MAGNOLIA BRANCH ESTATES SUBDIVISION, **REBSUBDIVISION OF AND ADDITION TO**

APPLICATION NUMBER 23 DATE April 7, 2005
APPLICANT Magnolia Branch Estates Sub, Resub of and Addition to
REQUEST Subdivision

MAGNOLIA BRANCH ESTATES SUBDIVISION, RESUBDIVISION OF ADDITION TO

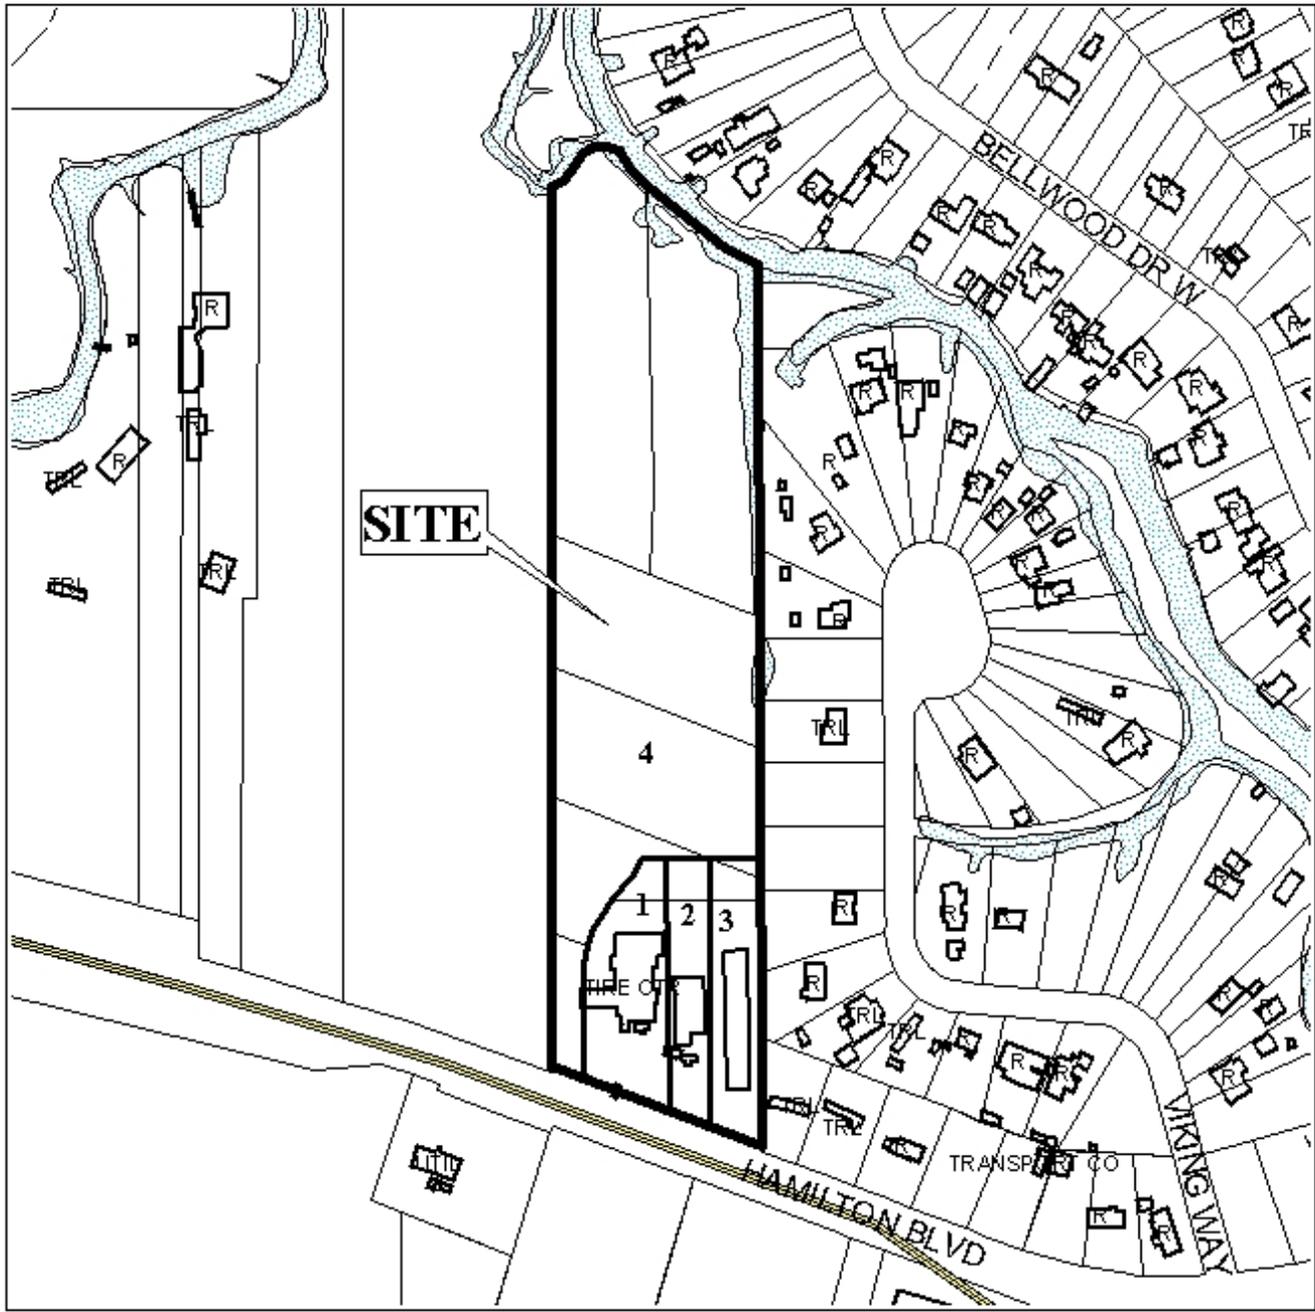
The site fronts Hamilton Boulevard, a planned major street. The current right-of-way width of 80 feet is less than the recommended width of 100 feet, according to the Major Street Plan. Therefore, the dedication of additional right-of-way to provide 50 feet from the centerline of Hamilton Boulevard should be required.

As the site fronts a major street, access management is a concern. According to year 2002 aerial photos, the site has two driveways onto Hamilton Boulevard: proposed lots 1-3 share one driveway, while proposed lot 4 has one driveway. Due to the limited width of the frontage along Hamilton Boulevard, a maximum of one driveway per lot should be permitted, but shared driveway access (as currently exists) is strongly encouraged to continue, rather than increasing the number of driveways. The location, size, and design of any additional driveways must be approved by County Engineering.

The proposed subdivision will result in four lots with a range of depth to width ratios. Section V.D.3. of the Subdivision Regulations recommends a maximum depth to width ratio of 3.5 (depth is 3.5 times the width of the lot). Depth to width ratios for parcels in the area vary widely, and the area is potentially environmentally sensitive, thus a waiver of V.D.3. could be considered appropriate.

The northern portion of the site is bounded by the Magnolia Branch of Alligator Bayou, a tributary to Dog River. Wetlands associated with the bayou may occur on the site. Furthermore, a substantial portion of the site appears to be located in the "AE" zone as depicted on FEMA maps, and thus may be subject to "100-year" frequency flooding. The presence of

wetlands and floodplains indicate that the area may be environmentally sensitive; therefore, the approval of all applicable federal, state and local agencies would be required prior to the issuance of any permits.

The site is located in the County, thus a note should be placed on the final plat stating that any lots which are developed commercially and adjoin residentially developed property must provide a buffer, in compliance with Section V.A.7. of the Subdivision Regulations.

With a waiver of Section V.D.3., the plat is recommended for Tentative Approval subject to the following conditions: 1) placement of a note on the Final Plat stating that lots 1-4 are limited to one curb cut each, with curb cut number, sizes, location and design to be approved by County Engineering; 2) approval of all applicable federal, state and local agencies regarding the wetlands and floodplain issues prior to the issuance of any permits; and 3) placement of a note on the Final Plat stating that any lots which are developed commercially and adjoin residentially developed property must provide a buffer, in compliance with Section V.A.7. of the Subdivision Regulations.
